RE: Juan Tabo Hills Estates
Drainage Report- Onsite Drainage Analysis, Volume 1 of 3, Addendum 1 (HGL)
Stamp Date: 3/8/2017
Hydrology File- M21D018; DRB# 1005278; CoA Project# 654887

Based on the information provided in your submittal received 3/16/17, the Drainage Report is approved for Work Order for construction of the subdivision public improvements (CPN# 654887) with the following understanding:

RE: Juan Tabo Hills Estates
Drainage Report- Onsite Drainage Analysis, Volume 1 of 3, Addendum 1 (HGL)
Stamp Date: 3/8/2017
Hydrology File- M21D018; DRB# 1005278; CoA Project# 654887

**Juan Tabo Hills Estates
Onsite Drainage Analysis Report
Volume 1 of 3
Addendum 1 (HGL)**

CITY PROJECT NO. 654887 ZONE MAP NO. H-21 SHEET OF 75

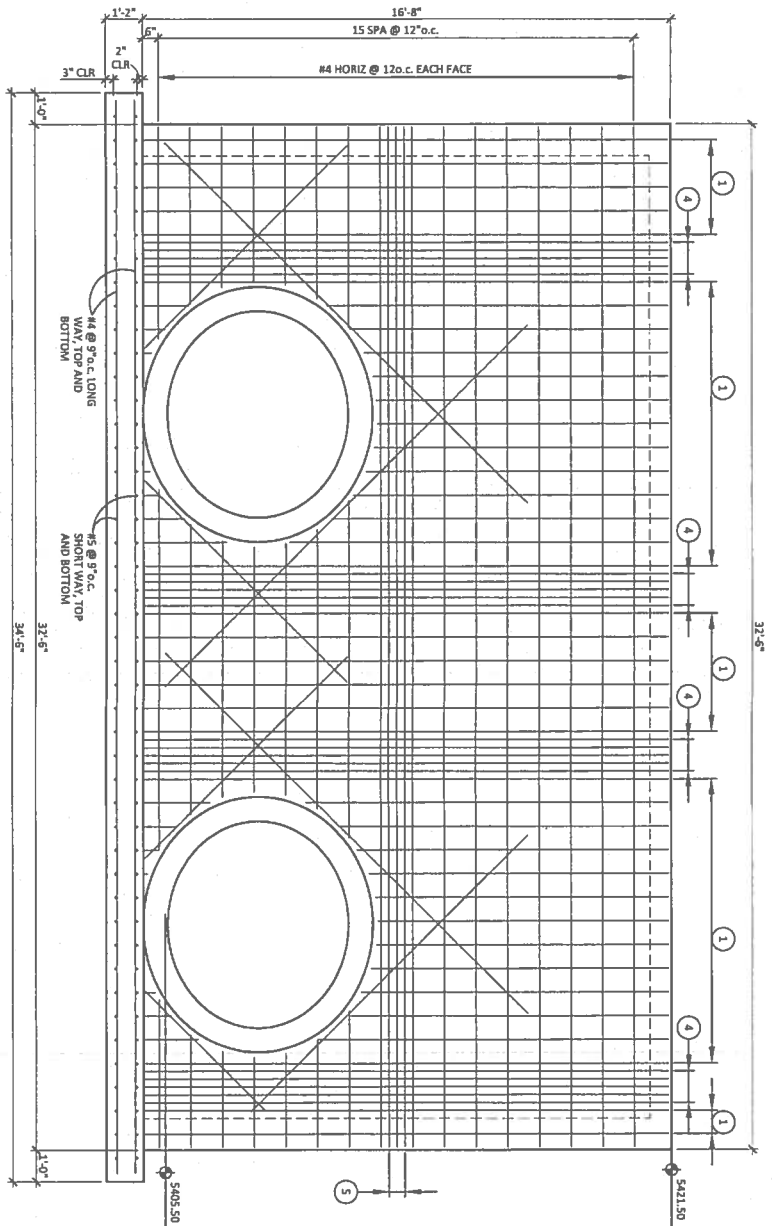
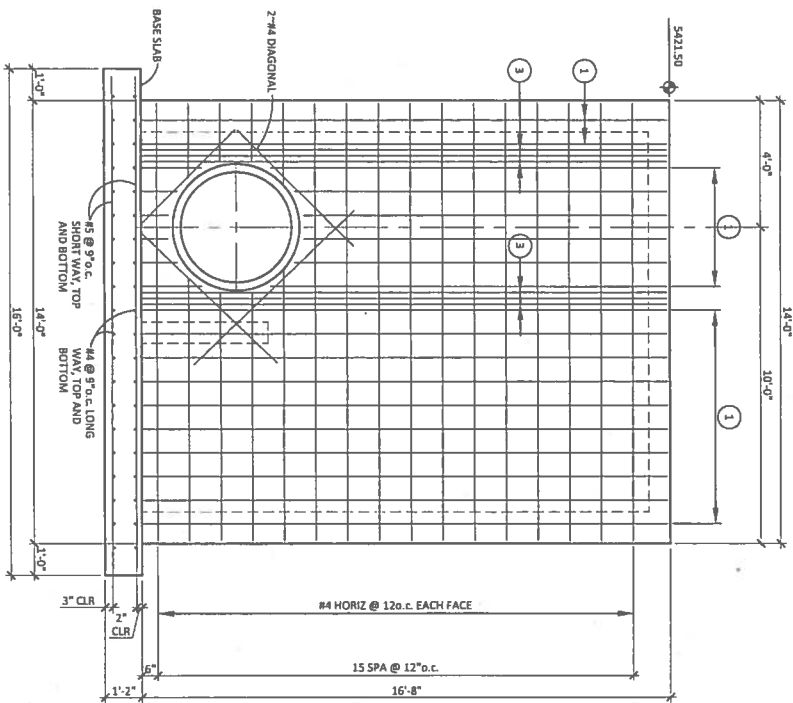
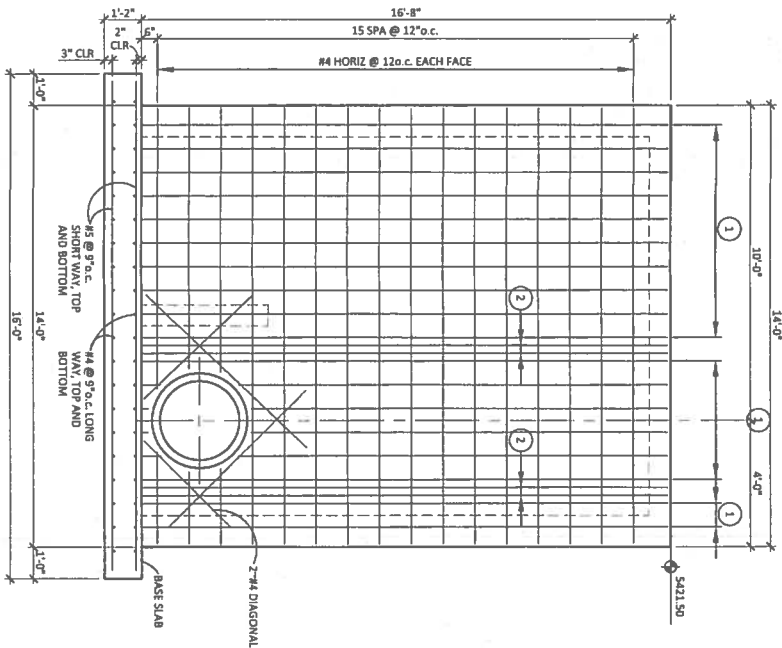
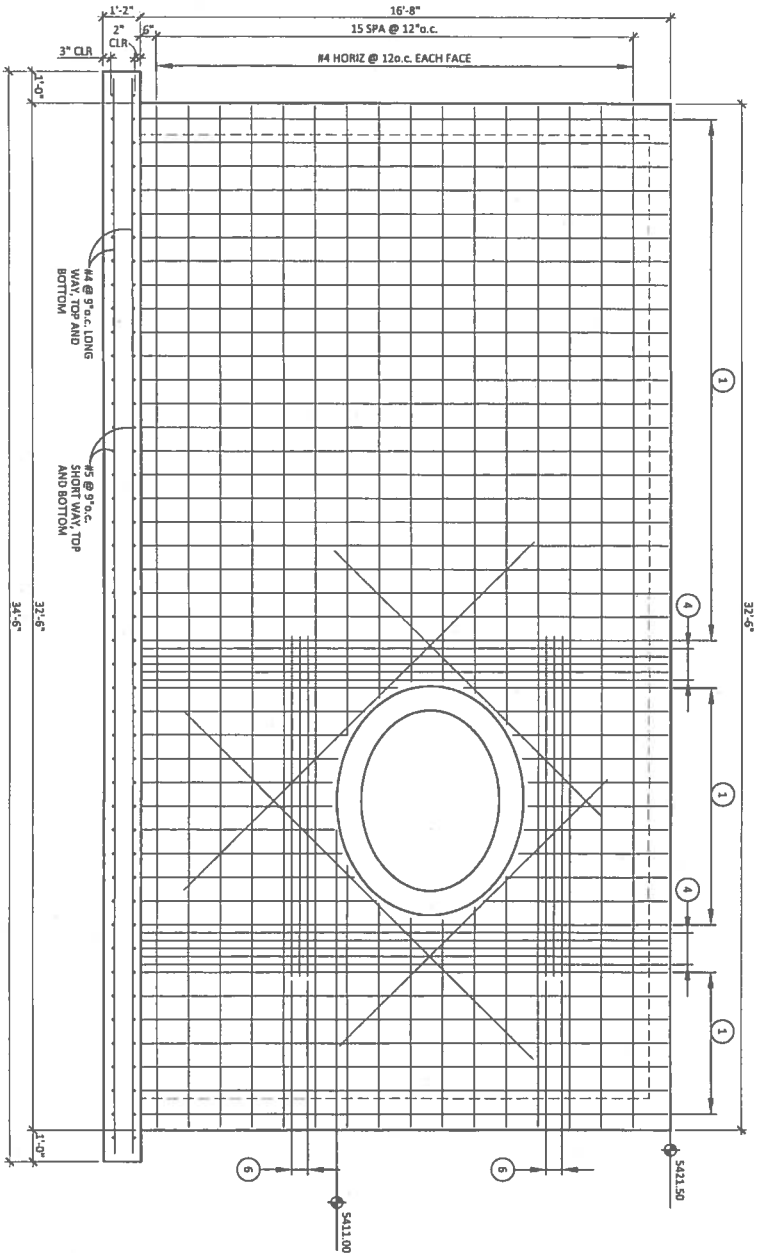
4. As-built drawings for CPN#688854 (Sandia Sunset stormdrain trunk) will need to be updated to reflect the updated velocities and flows.
5. Per the City Engineer, 1 1/2" clear space between reinforcement and form work is insufficient and needs to be increased to 2"-3". This applies to sheet 73.
